Addendum No. 3

Request for Proposals

PORT DOCK IMPROVEMENTS FOR THE PORT AUTHORITY OF KANSAS CITY GOVERNOR MICHAEL L PARSON PORT TERMINAL

Date of Issuance: March 29, 2024

Sheet Pile & Concrete Dock Fenders - Model 114

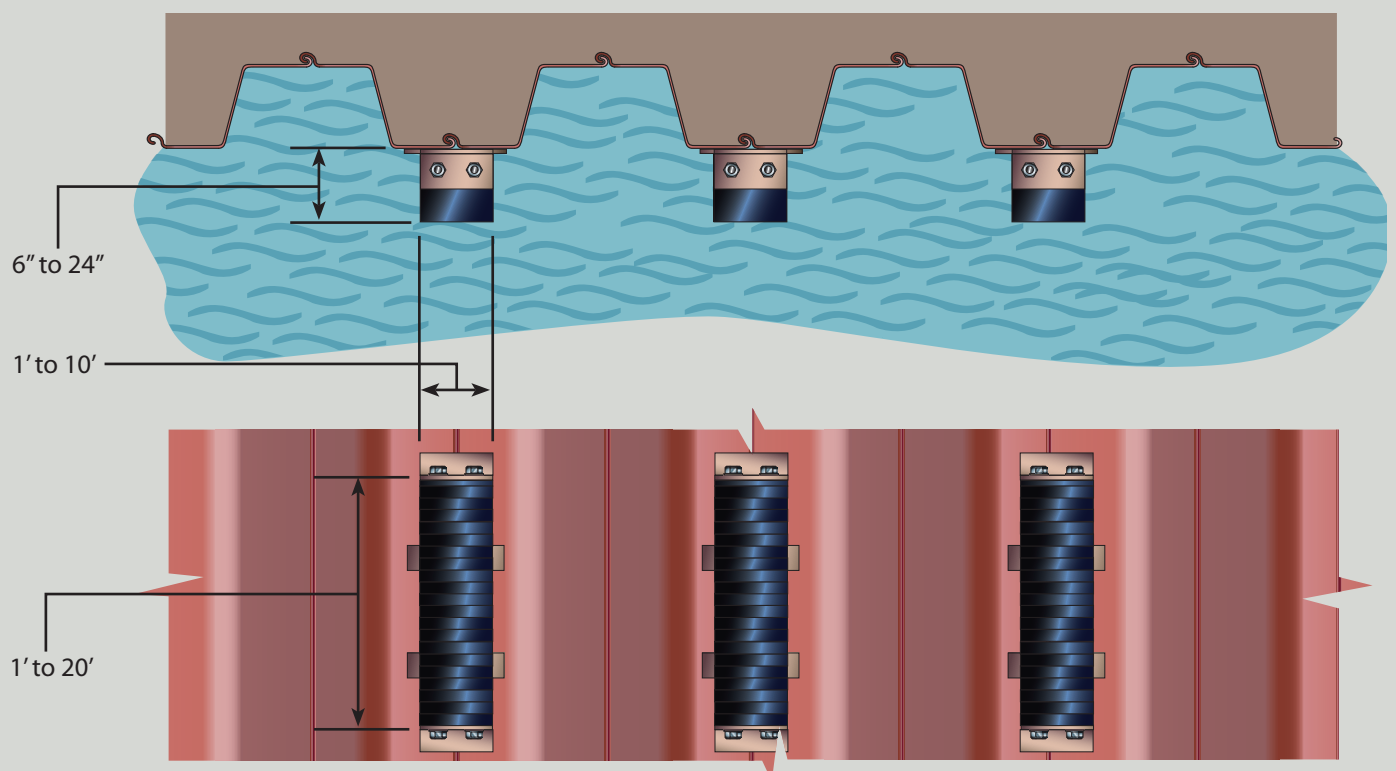
- 20) What is going to be required for soil erosion and stormwater protection?
- a. See plan general notes on cover.*
- 21) Do you have a detail on the wall fenders?

- a. Sheet pile fenders will be as manufactured by Schuyler Companies or approved equal. See attached pdf.*
- 22) Do you have a detail of the new bulkhead wall closures? How do these returns tie in?
